**STAFF REPORT**  
**COMMUNITY DEVELOPMENT DEPARTMENT**

HEARING DATE: 6/7/2022  
 TO: Mayor & City Council  
 FROM: Joe Dodson, Associate Planner  
 208-884-5533  
 SUBJECT: H-2022-0014  
 Grayson Subdivision  
 LOCATION: Located at 1710 E. Amity Road, near the northeast corner of E. Amity Road and S. Locust Grove Road, in the SW 1/4 of the SW 1/4 of Section 29, Township 3N, Range 1E.

Request for Annexation and Zoning of 3.39 acres from RUT to the R-8 zoning district and a Preliminary Plat consisting of 15 single-family residential building lots and 3 common lots on 3.1 acres of land in the requested R-8 zoning district, by Schultz Development, LLC.

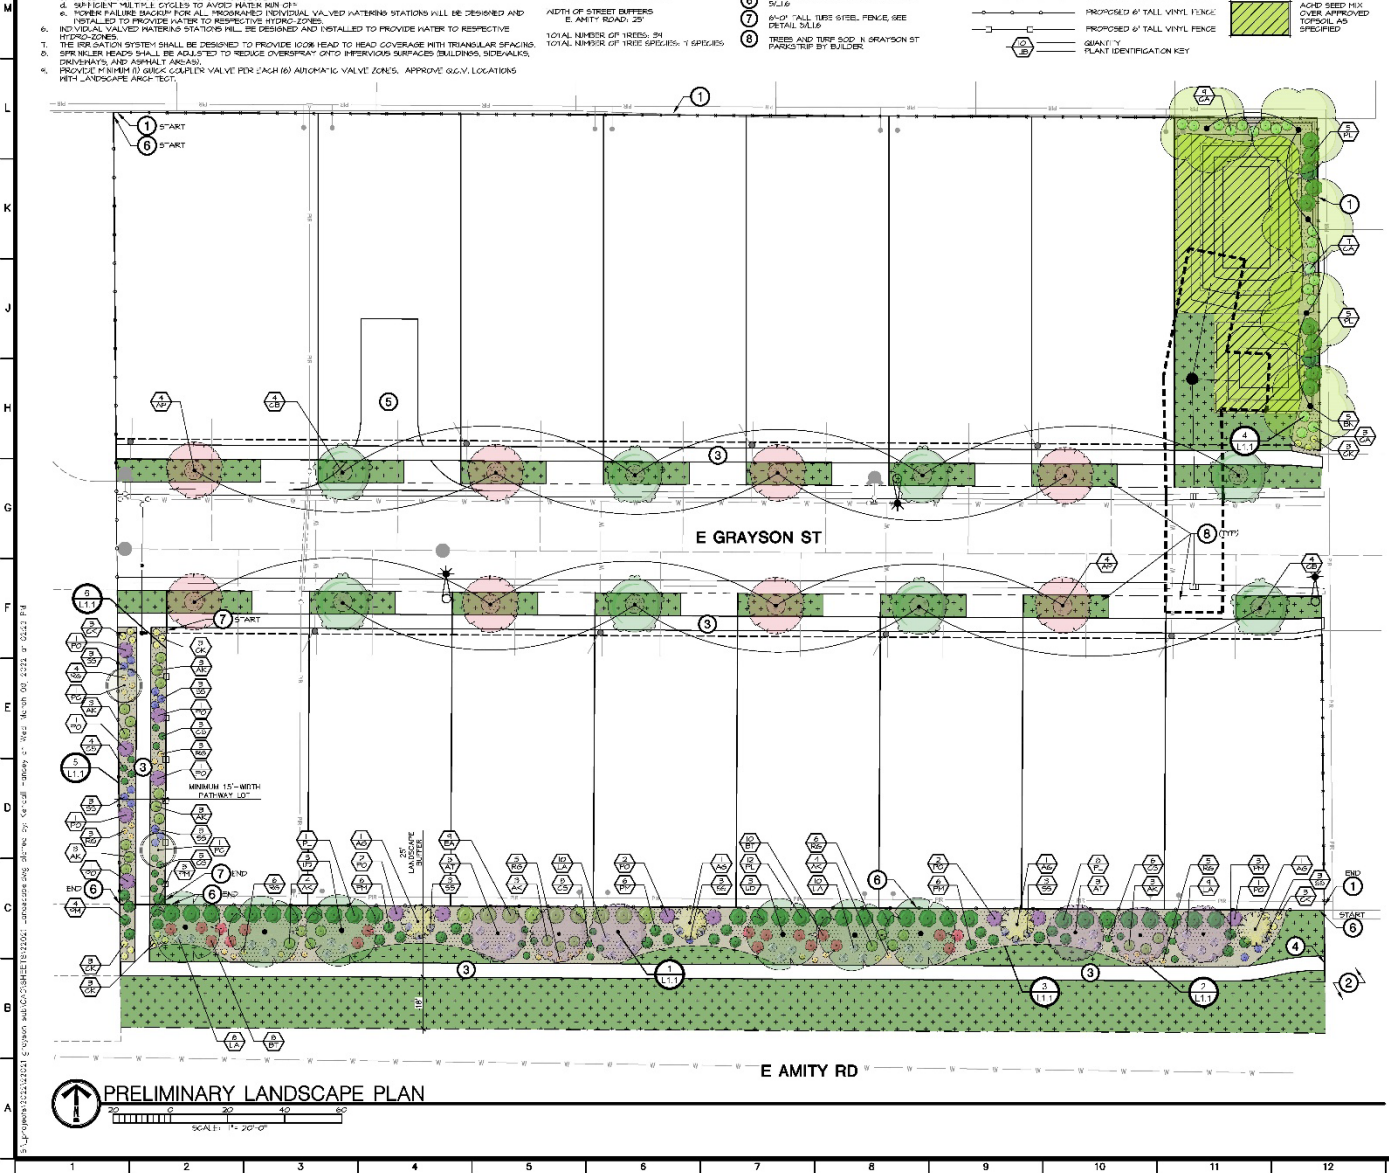
*The Applicant has proposed a 5-foot wide detached sidewalk within the Amity Road street buffer which does not comply with this requirement. Therefore, Staff is including a condition of approval for the Applicant to revise the landscape plans to depict the required regional pathway within this buffer. Furthermore, this pathway should be at least four (4) feet north of the ultimate right-of-way line to allow for landscaping on both sides of the pathway and ensure the pathway is detached from the roadway and allow the 25-foot buffer to be measured from the ultimate right-of-way instead of the back of the pathway, per UDC 11-3B-7C.1a.*

*As noted above, the proposed 8-foot wide parkways do not appear to depict the correct number of street trees. Each parkway is approximately 420 feet long which requires a minimum of 12 trees on each side of Grayson Street. The submitted landscape plans depict 8 trees within each parkway so an additional four (4) trees are needed on each side of the street. Staff is including a condition of approval consistent with this requirement.*

4. The preliminary plat included in Section VII.B, dated February 17, 2022, is approved as submitted.
5. The landscape plan included in Section VII.C, dated March 9, 2022, shall be revised as follows prior to submitting for Final Plat approval:

- a. Depict the correct number of street trees within the parkway per UDC 11-3B-7.
  - b. Add seating and a shade structure within the drainage common lot (Lot 1, Block 1).

- c. Depict the required 10-foot wide regional pathway within the Amity Road landscape buffer and place it at least four (4) feet north of the ultimate right-of-way line to allow for landscaping on both sides of the pathway and ensure the pathway is detached from the roadway and allow the 25-foot buffer to be measured from the ultimate right-of-way instead of the back of the pathway, per UDC 11-3B-7C.1a.

- d. Common Lot 1, Block 1 shall meet minimum standards in UDC 11-3B-11.
  - e. Common Lot 9, Block 2 shall be landscaped as proposed.

E. Temporary Turnaround Options – West terminus of E. Grayson Street extension

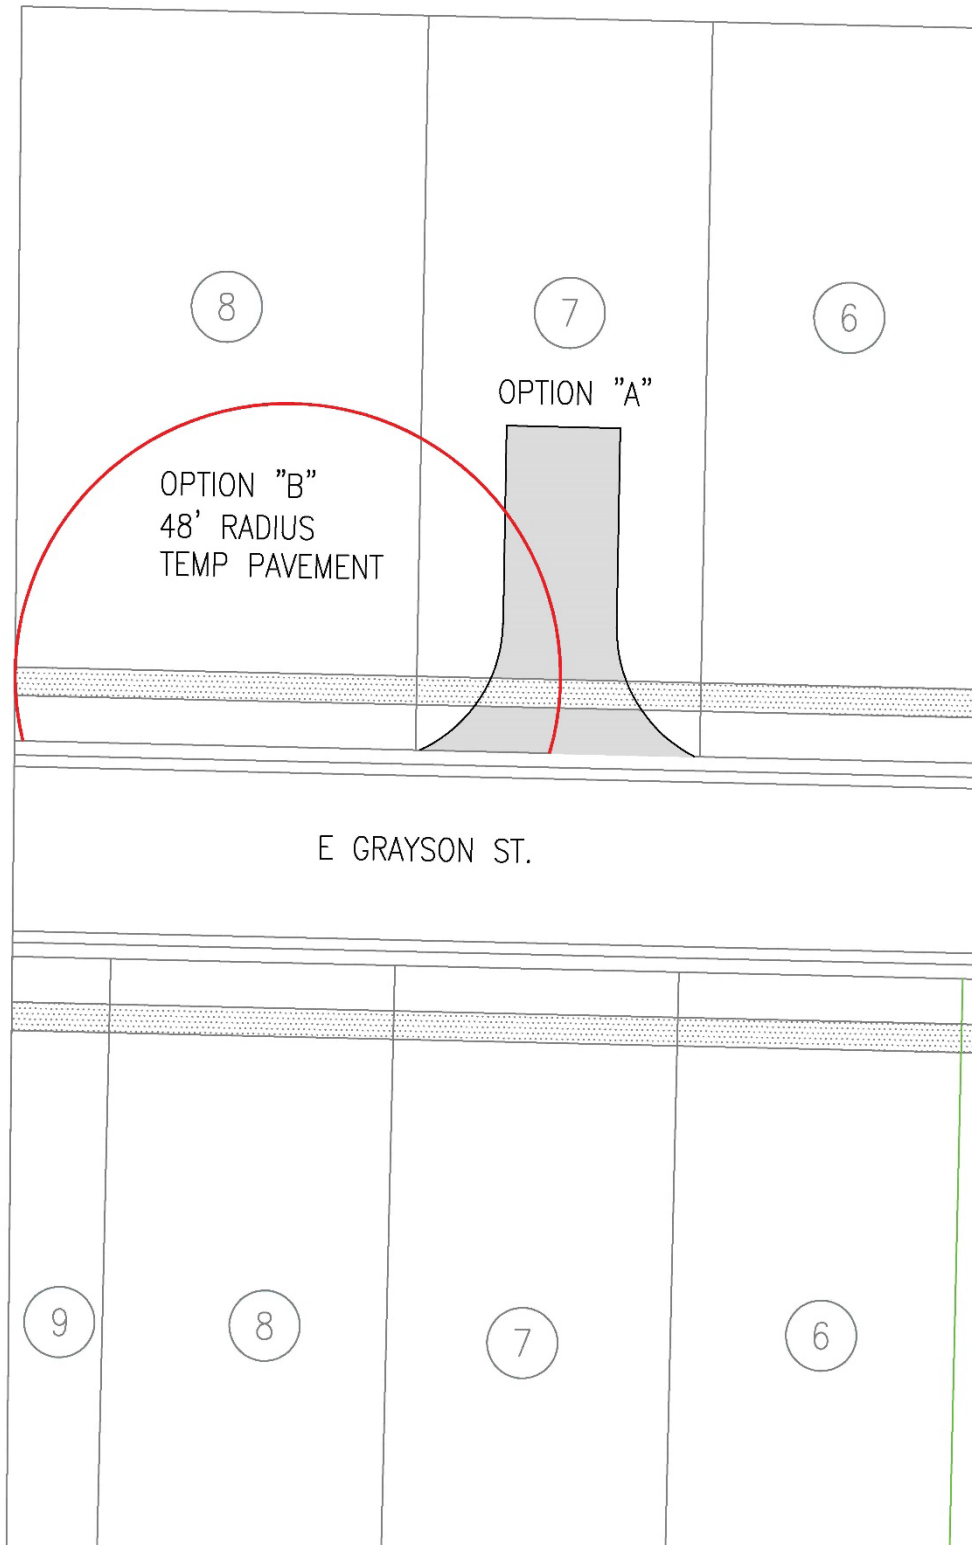
*In addition to these elements, the proposed termination of the Grayson Street extension should be discussed. Specifically, this Applicant has proposed to stub Grayson to the west boundary as required by ACHD and the UDC but is showing a temporary hammerhead-type turnaround that encumbers a building lot, Lot 7, Block 1. Typically, ACHD has not allowed this type of turnaround in recent years, even on a temporary basis. The Fire Department and Planning Staff support the proposed design as it meets Fire requirements and does not make two future lots non-buildable for the near future. However, Staff anticipates ACHD will not approve this temporary turnaround. So, the Applicant has provided an exhibit showing Lots 7 & 8, Block 1 encumbered by an offset cul-de-sac as an alternative temporary turnaround should ACHD not allow the hammerhead. See snip below and Exhibit VII.E for this proposal:*

Access is proposed via extension of E. Grayson Street (an existing residential local street) into the site and is proposed to terminate within the site at the west boundary for future connectivity. As discussed above, the Applicant is proposing to provide a temporary hammerhead-type turnaround instead of a temporary cul-de-sac. Staff supports this temporary turnaround design in order to save space and minimize the waste of asphalt within this development but anticipates ACHD will not approve this type of temporary turnaround. **If ACHD does not approve the hammerhead design as recommended by Staff, the applicant shall restrict Lots 7 and 8 as non-buildable lots as proposed and place a note on the final plat stating these lots will be developable with the extension of the public street.**

2. The applicant is seeking a Council waiver for E. Grayson Street to be a dead-end street greater than 500 feet in length, per UDC 11-6C-3B.4.
3. Per Exhibit VII.E attached hereto, E. Grayson Street shall terminate along the west property boundary as either a temporary cul-de-sac or hammerhead type turnaround—if a hammerhead type turnaround is approved by ACHD, Lot 7, Block 1 shall be a non-buildable lot until such time as Grayson is further extended; if a cul-de-sac turnaround is required, Lots 7 & 8, Block 1 shall be non-buildable lots until such time as Grayson is further extended.
